# **AEROPRAKT SERVICE BULLETIN**

## **№ SB A22LS-19**

### **REPLACEMENT OF THE NOSE WHEEL FORK HINGE BRACKET OF A22LS AND A22L2 AIRCRAFT**

**Photo 12**

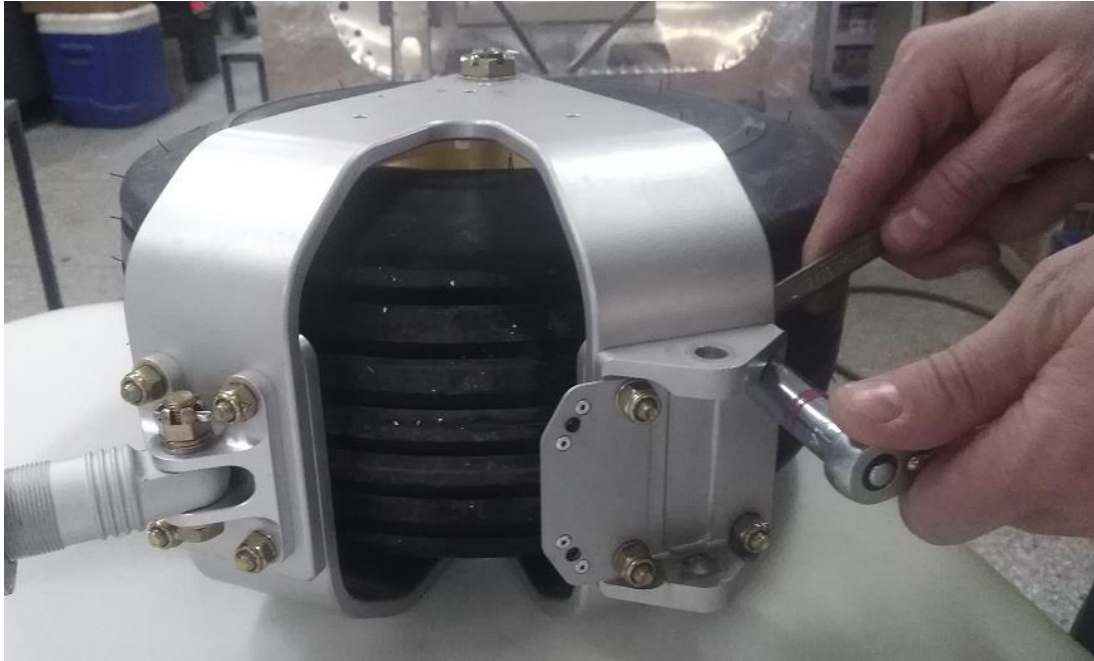
3.11) Undo the nuts attaching the bracket to the wheel fork (Photo 12).

**Photo 14**

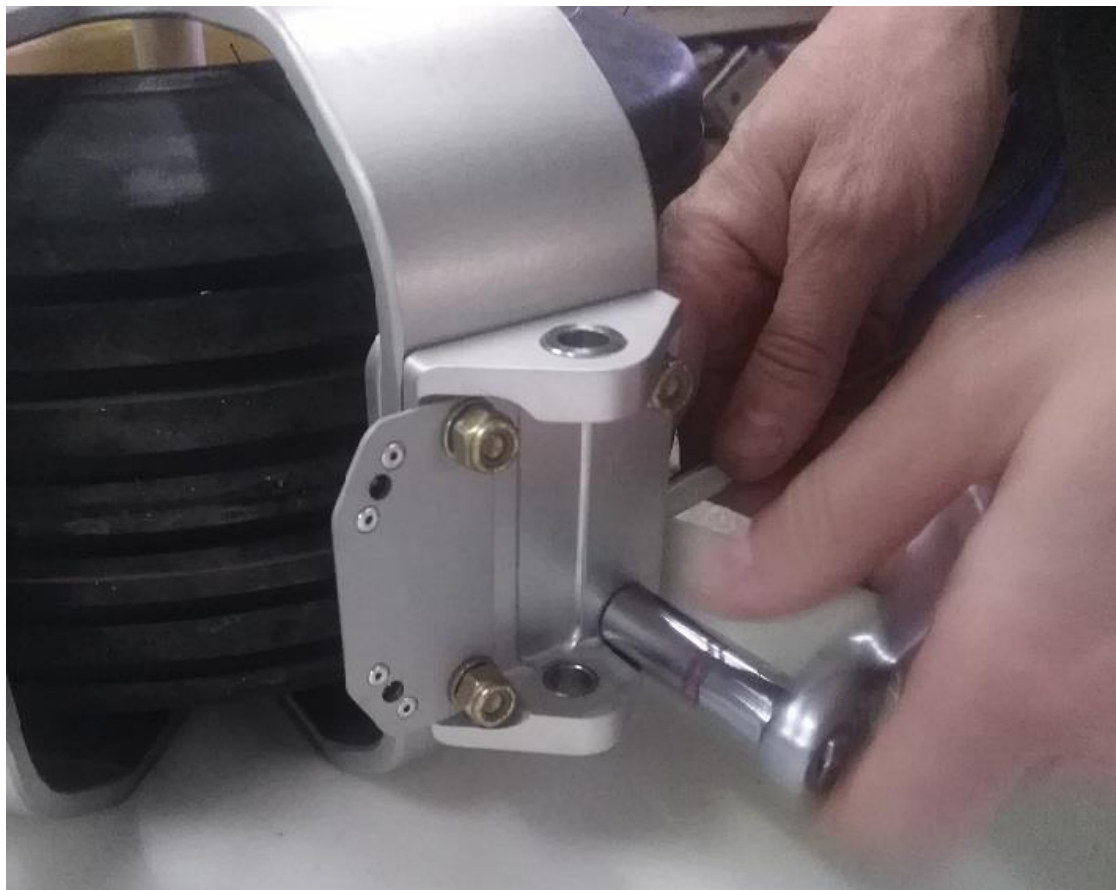
3.13) Install the new bracket and tighten the nuts (Photo 14).
